JUSTIFICATION

REMOVAL OF INTERNAL CASEMENT WINDOWS

107 HIGH STREET, LINDFIELD, HAYWARDS HEATH, RH16 2HR

Proposed ground floor plan

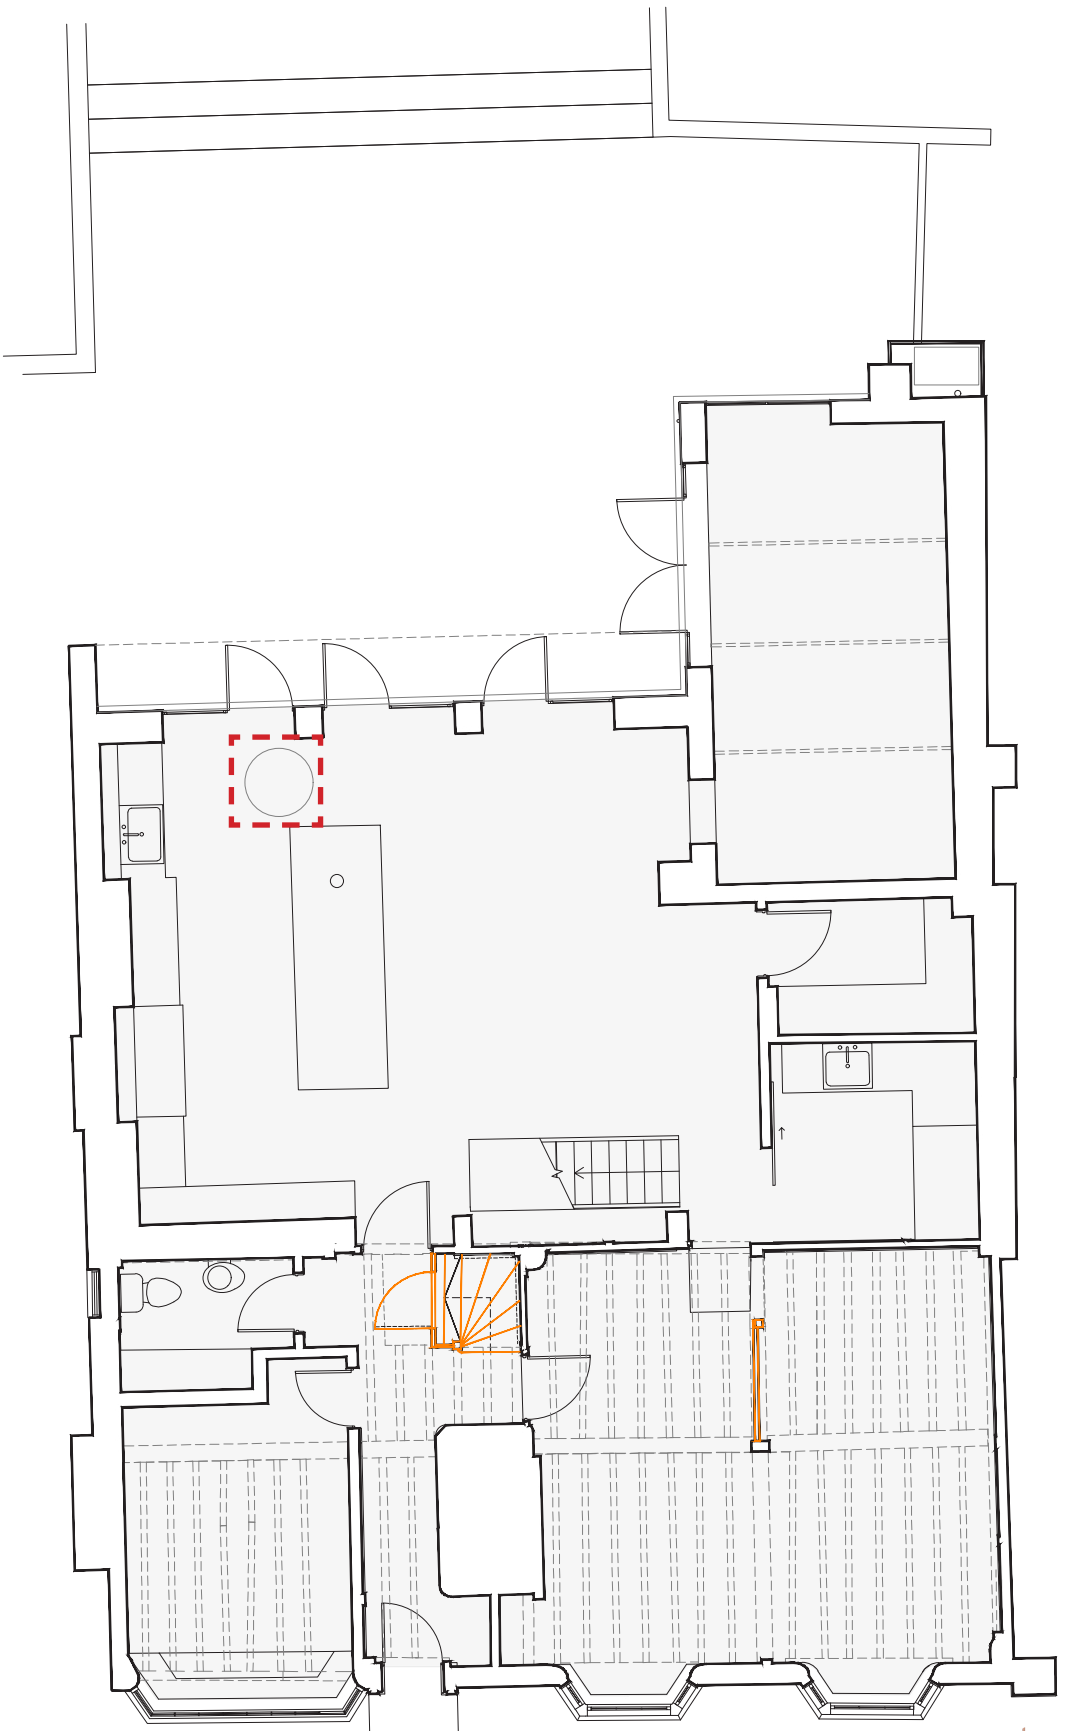
A historic well was discovered during the course of construction works and retained as an internal feature within the rear extension. Historic fabric of well has been retained. New brick lining placed in front on a lintel within the well. A glass cover was added, allowing full view into the well. The following works were undertaken:

- 3. Relining the shaft
Shaft relined with the multicoloured Hamsey Mixed Stock brickwork to stabilise the structure, prevent collapse of soil around it, and provide a neat vertical surface. Brick lining laid in lime mortar.

1. Approved Garage Drawings

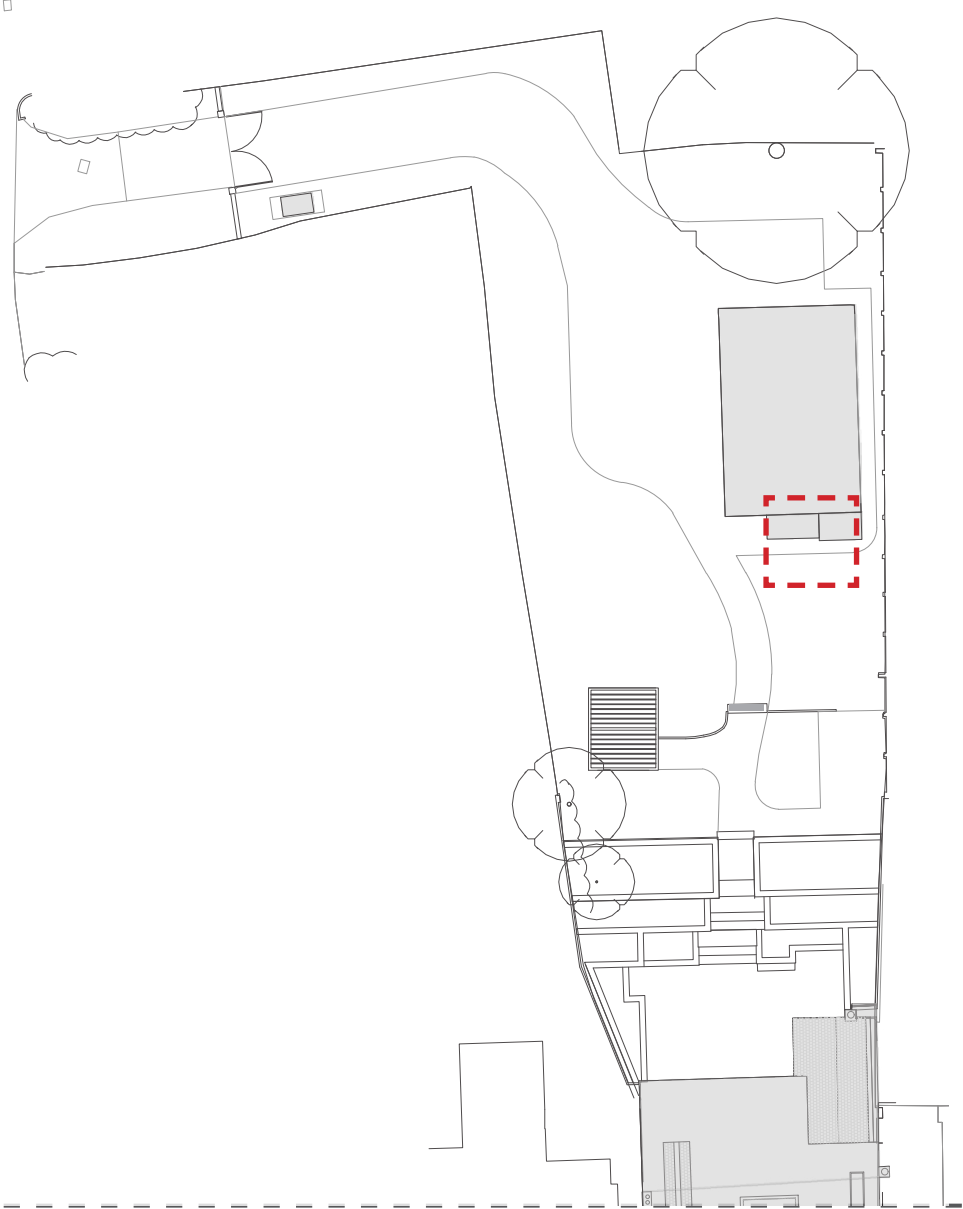
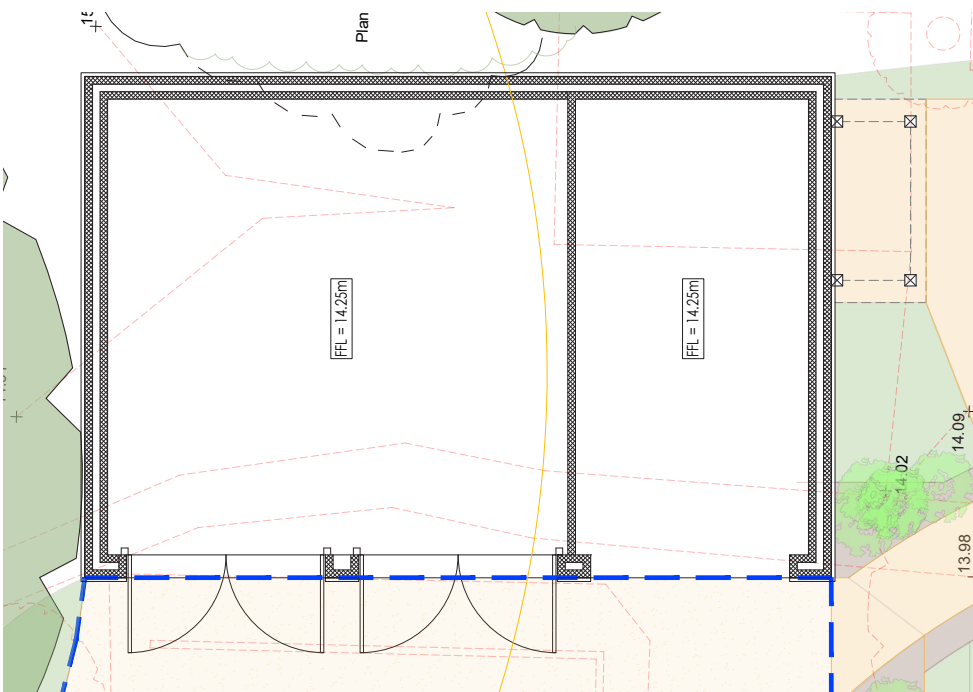
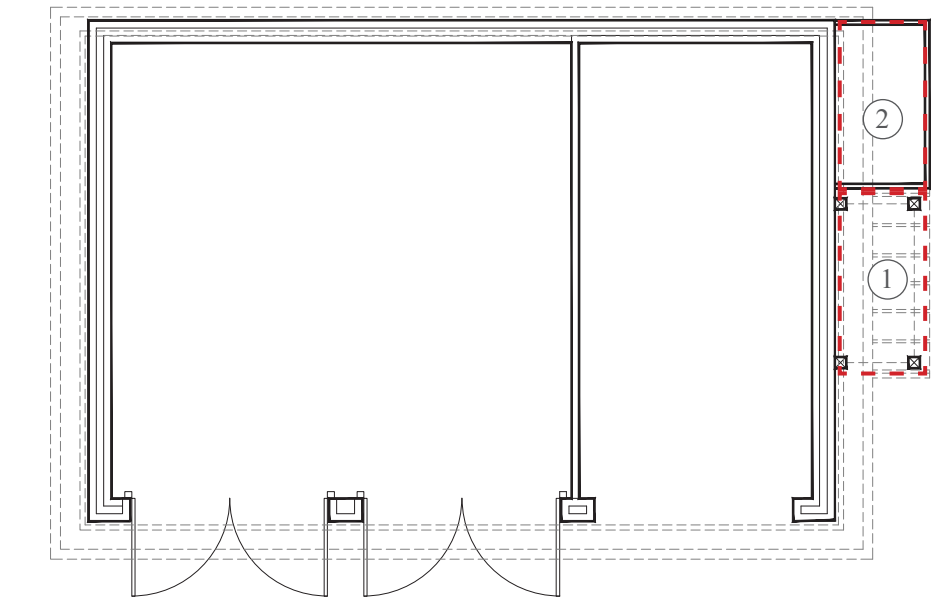
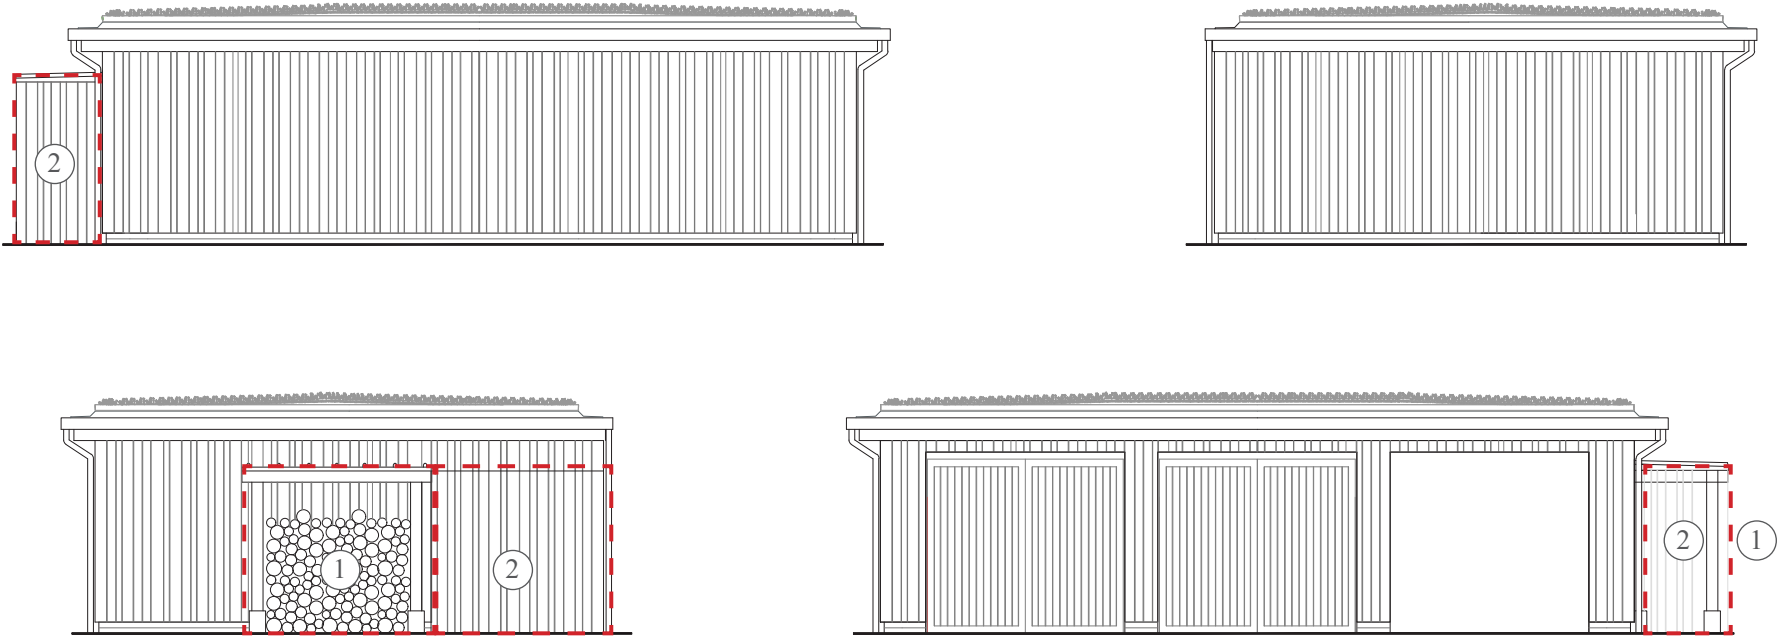
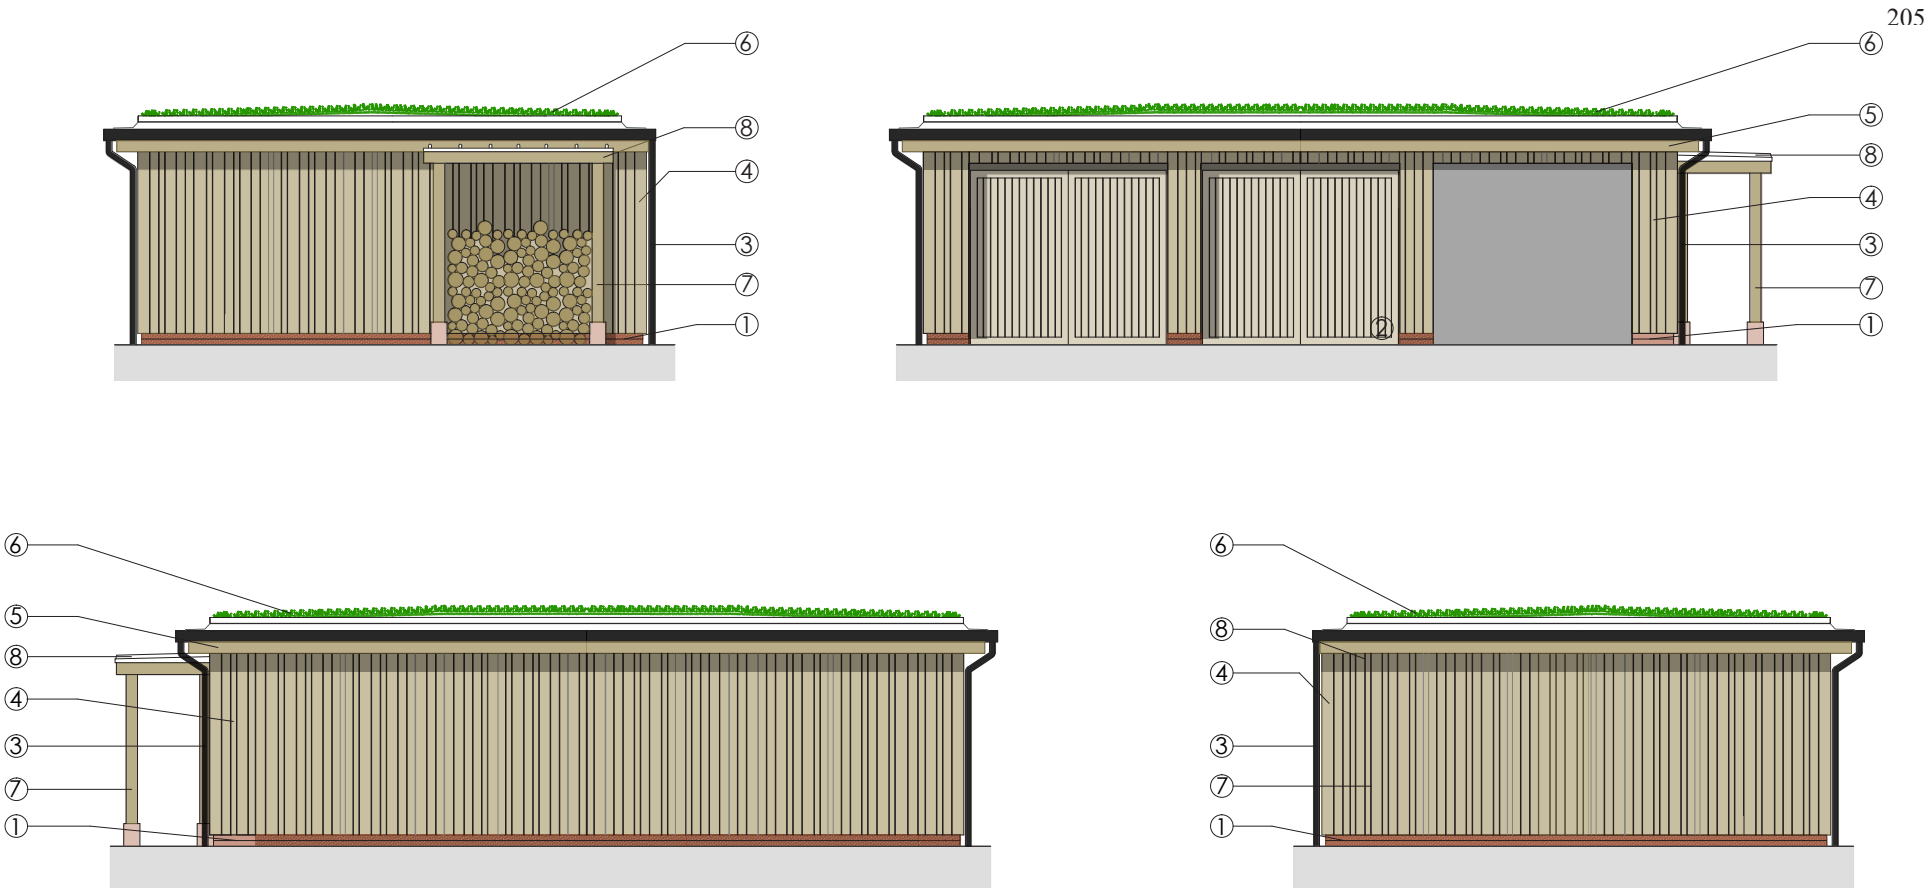
The garage has been constructed with minor variation to the approved scheme - the approved log store was constructed lower and in shifted location (centre of the elevation instead of side).

- Highlighted area of deviation
- 1 Timber log store
- 2 Irrigation tank enclosure

Recent photographs of the irrigation tank enclosure

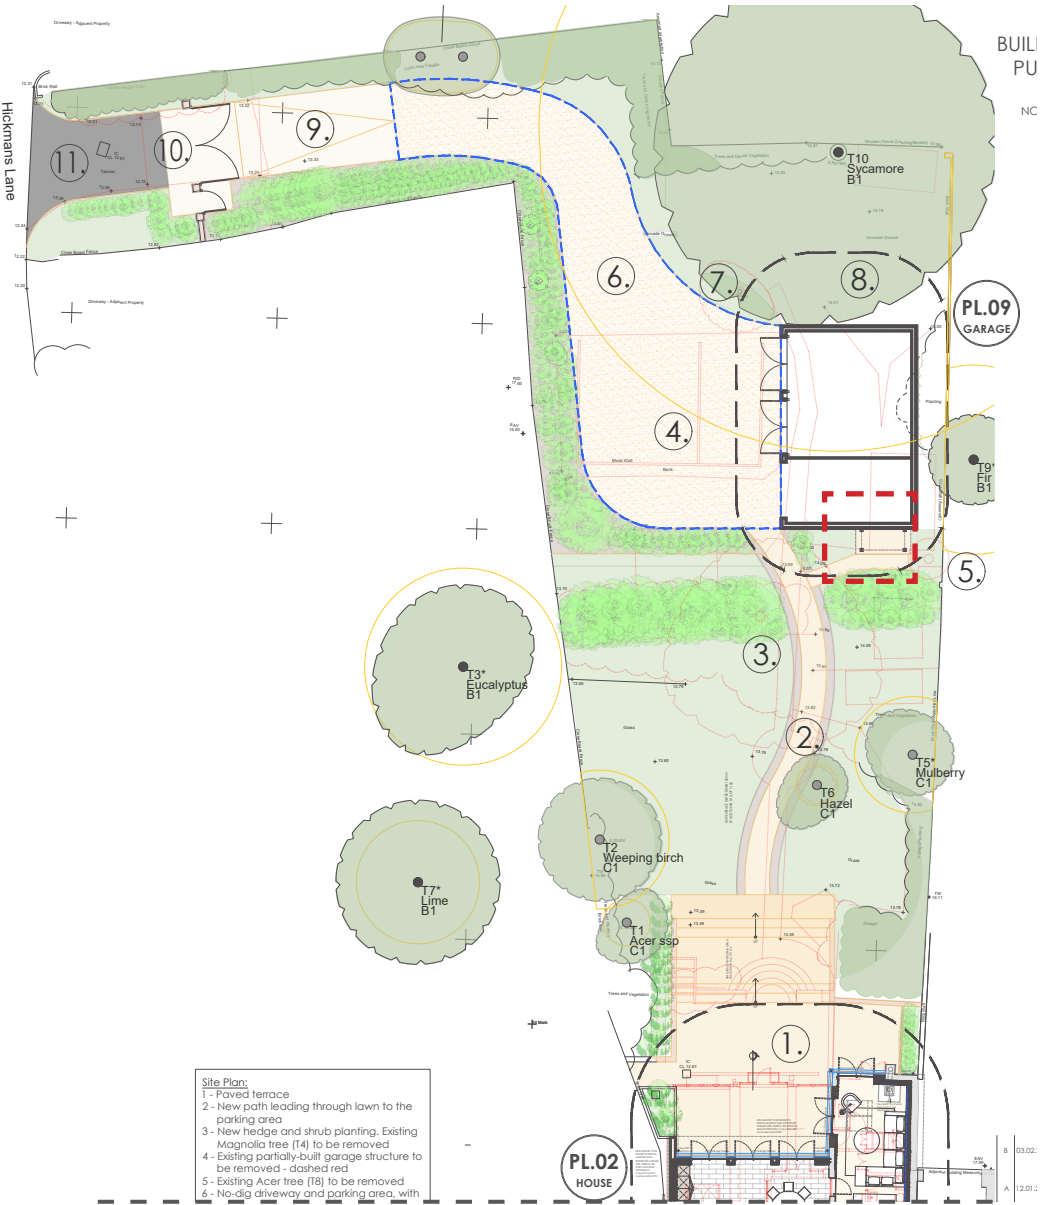
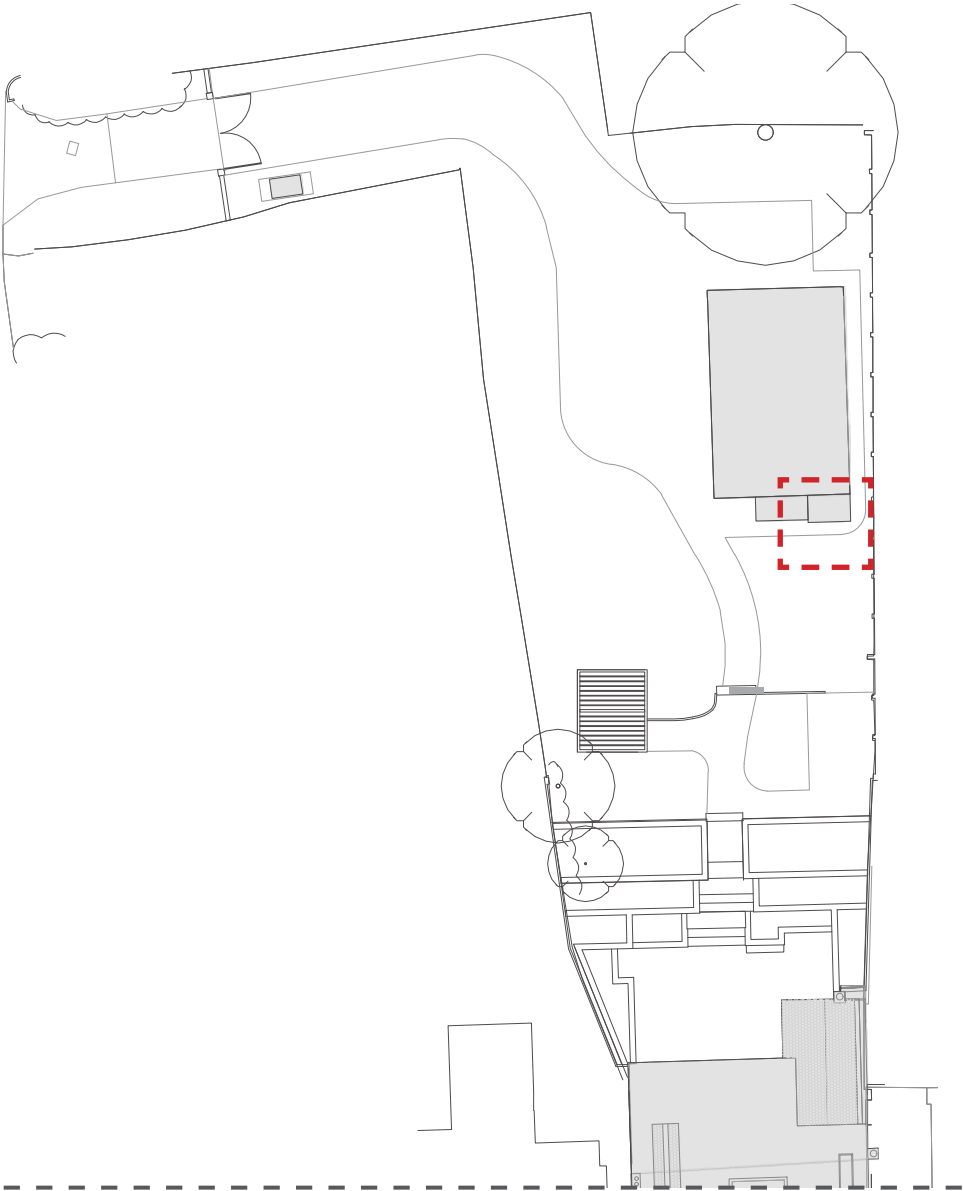
The irrigation tank enclosure was constructed without planning permission and is a part of retrospective works applied for under this application.

The enclosure was constructed in a sensible manner, using vertical timber panels matching garage cladding. The enclosure is located in a discreet location, adjacent to the garage. As presented on adjacent recent photographs. The reduced height log store is a slight improvement on the approved design. The enclosure is barely noticeable. It is considered to be of low harm to the listed building setting.
